# PECOS DISTRICT CONDITIONS OF APPROVAL

30-027-400	' 16
OPERATOR'S NAME:	COG Operating	
LEASE NO.:	LC029509A	
WELL NAME & NO.:	M C federal 57	
SURFACE HOLE FOOTAGE:	2561' FSL & 1567' FEL	
BOTTOM HOLE FOOTAGE	2310' FSL & 990' FEL	
LOCATION:	Section 21, T. 17 S., R 32 E., NMPM	
COUNTY:	Eddy County, New Mexico

Figure 1 - Cross Sections and Plans For Typical Road Sections

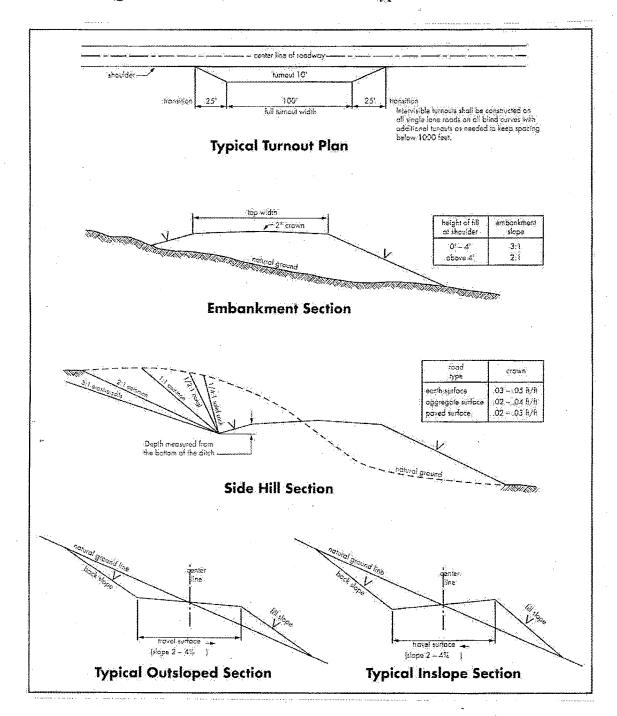
Crowning shall be done on the access road driving surface. The road crown shall have a grade of approximately 2% (i.e., a 1" crown on a 14' wide road). The road shall conform to Figure 1; cross section and plans for typical road construction.
